SERVICE BULLETIN

ENGINE — RING SEGMENT ASSEMBLIES, 2ND STAGE HIGH PRESSURE TURBINE
(HPT) — INTRODUCTION OF, FOR IMPROVED EFFICIENCY

V2500 Series 72-0649

V2500-ENG-72-0649

LOCATION OF THE RING SEGMENT AND VANE CLUSTER ASSEMBLY (BORESCOPE)
72-45-24
FIGURE 1

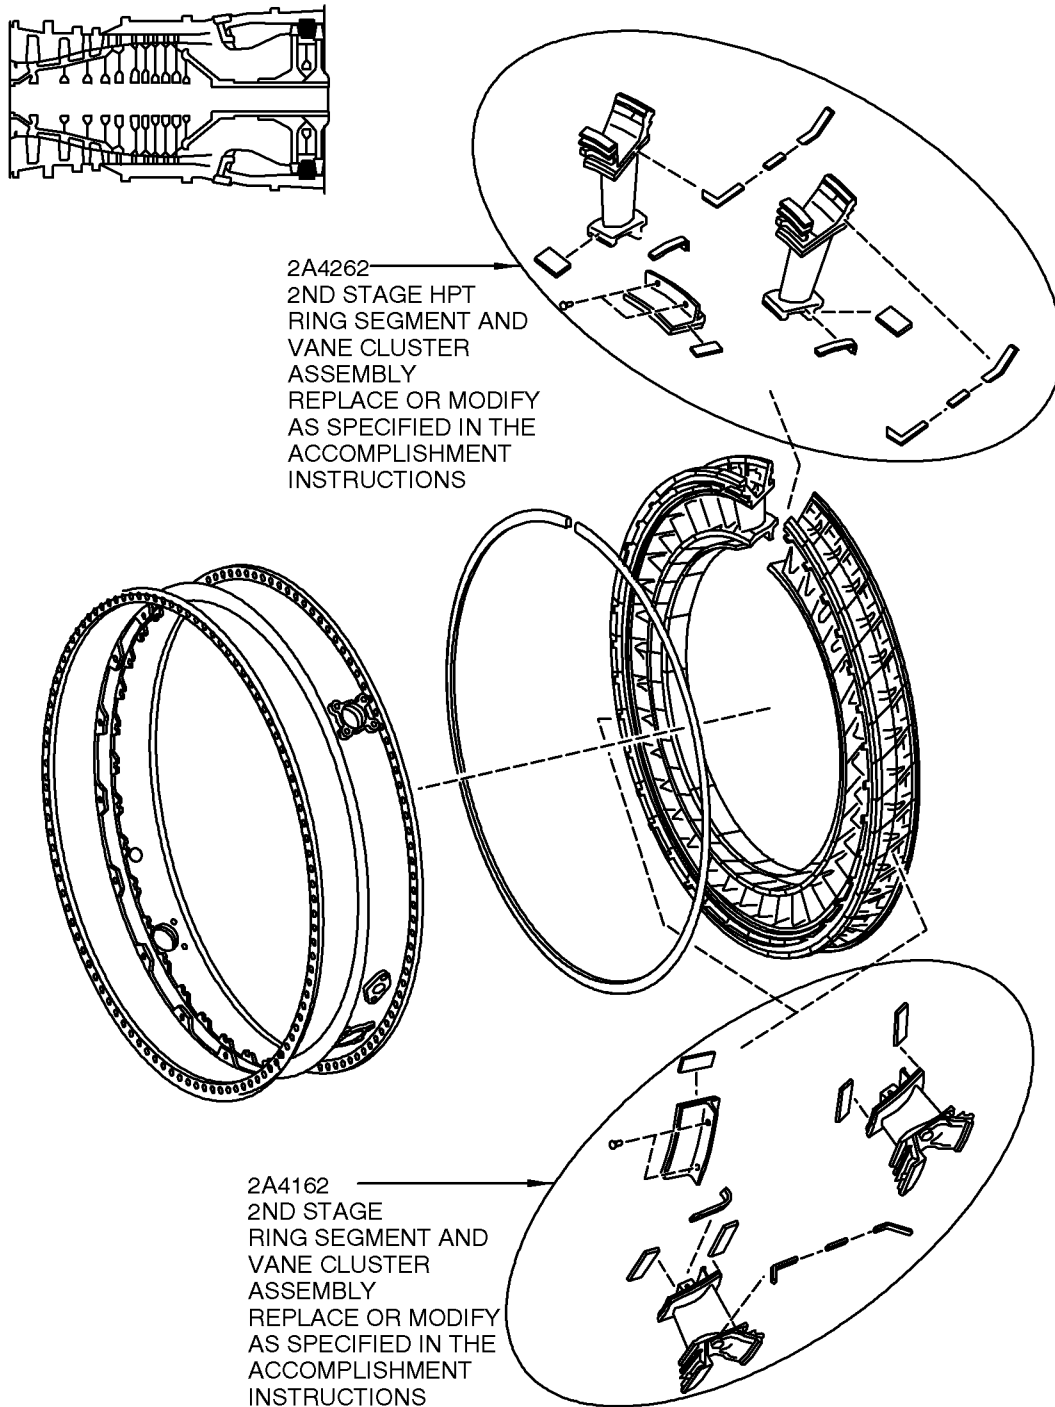
1. Replace the 17 2nd Stage HPT Vane Ring Segments, PN 2A4262 with PN 2A4462 or do a modification of the 2nd Stage HPT Vane Ring Segment, PN 2A4262. See Figure 1.
 - A. Send the parts to either vendor listed in the Vendor Services section. The modified 2nd Stage HPT Vane Ring Segment will be returned identified as given in Table 1 below.

2. Replace the two 2nd Stage Vane Ring Segments, PN 2A4162 with PN 2A4562 or do a modification of the 2nd Stage Vane Ring Segment, PN 2A4162. See Figure 1.
 - A. Send the parts to either vendor listed in the Vendor Services section. The modified 2nd Stage Vane Ring Segment will be returned identified as given in Table 2 below.

RING SEGMENT AND VANE CLUSTER ASSEMBLY (BORESCOPE) REF. CATALOG
SEQUENCE NO. 72-45-24 FIGURE 02 ITEM 050.
CHART A, SHEET 1

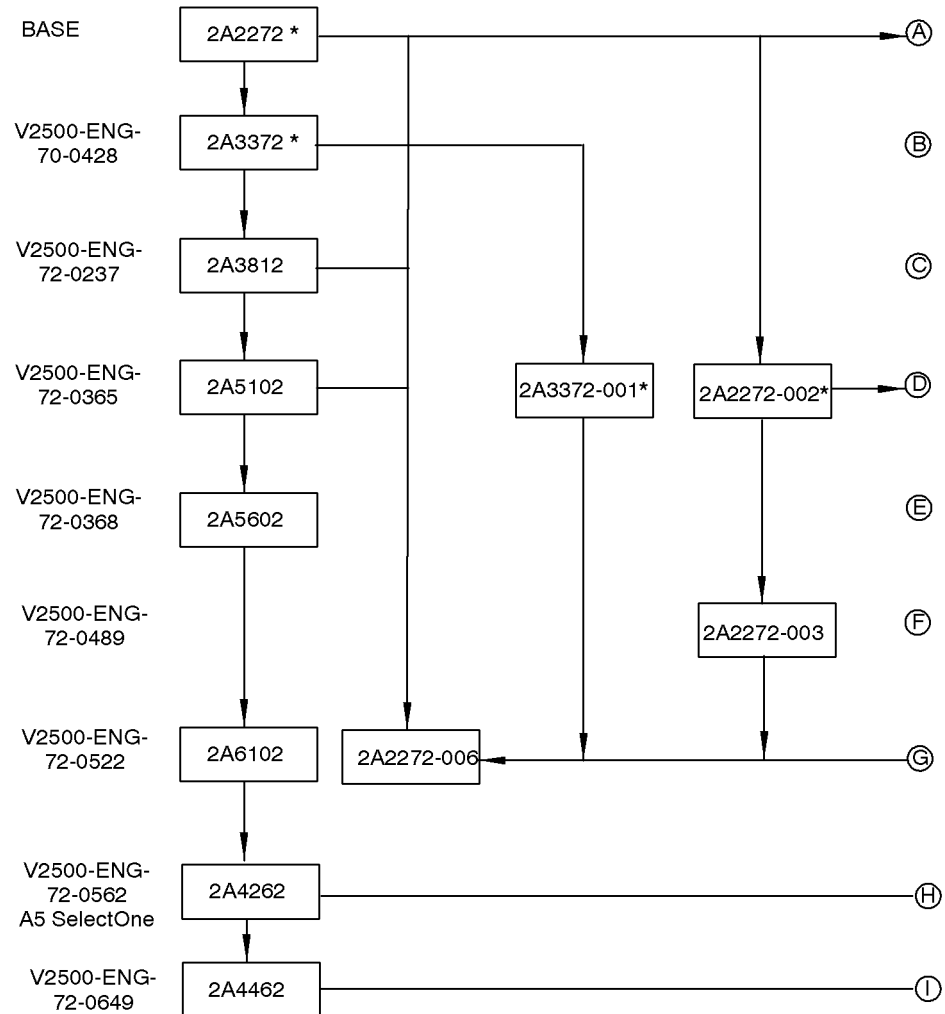
Parts Progression To Show the Changed Part in Relation to Other Parts
